COUNCIL ASSESSMENT PANEL

for the meeting  
Monday, 29 May 2023  
at 5.30 pm  
in the Colonel Light Room, Adelaide Town Hall

**Subject Site** 107-109 O'Connell Street, North Adelaide

**Nature of Development** Construct four storey detached dwelling

**Figure 9.5.1 – City High Street Subzone PO 3.1 Desired Interface Diagram**

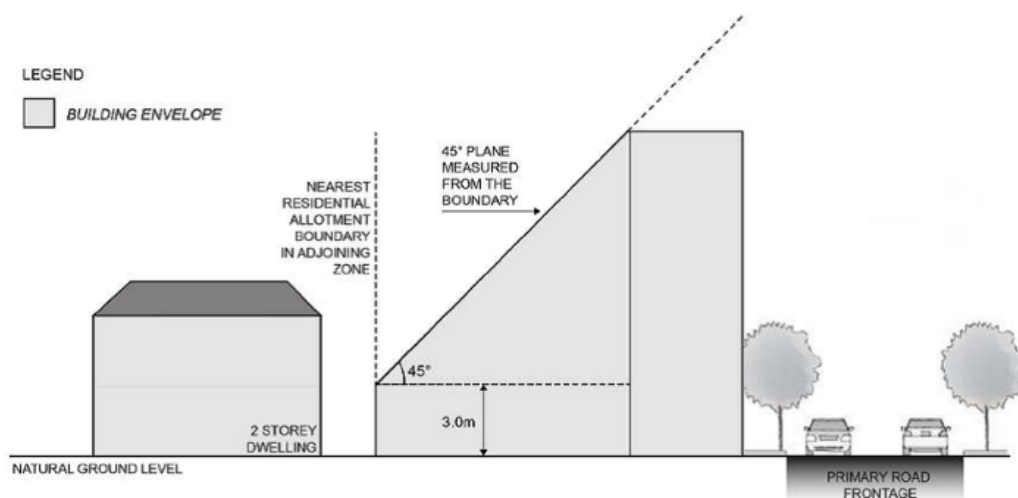
City High Street Subzone PO 3.1 seeks to limit the visual impact of building massing on residential development within the adjacent City Living Zone. DPF 3.1 specifies that, except where the subject site is a catalyst site, buildings be constructed within a building envelope provided by a 45 degree plane measured from a height of three metres above natural ground level at the boundary of an allotment used for residential purposes within the City Living Zone as shown in Figure 9.5.1.

This provision ensures development provides an orderly transition from the larger scale development in the City Main Street Zone to the lower scale development in the City Living Zone. The proposal extends beyond this plane by a significant degree with a four storey wall directly on the western boundary of the site shared with the City Living Zone. Consequently, the development is anticipated to result in a degree of visual impact to the adjacent residential property to the west.
